# PRODUCT CHANGE NOTIFICATION

## Common Mode Chip Inductor Core Lid Design Change

### Select Model SRF and SM Series

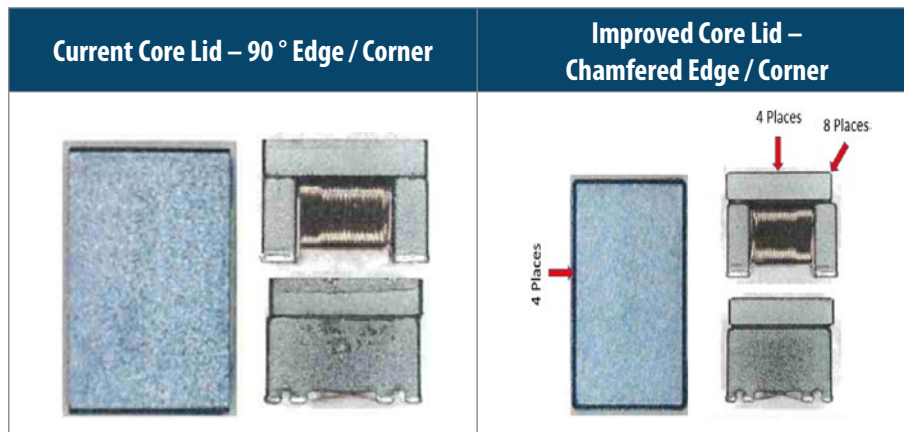
Riverside, California – February 24, 2020 – Effective immediately, Bourns is changing the inductor core lid design of several SRF and SM series Common Mode Chip Inductors to include chamfered edges and corners to help reduce chipping and cracking during assembly. A list of affected part numbers is available on the following page.

The current design of the inductor core lid edge and corner are formed at 90°. The right-angle edge and corner can potentially be chipped and cracked when the material is processed through a production vibratory feeder. The chamfered edge and corner core lid are being introduced to address the problem.

The form of the component will be changed. The fit and function remain unchanged. The reliability and quality of the inductor should be improved.
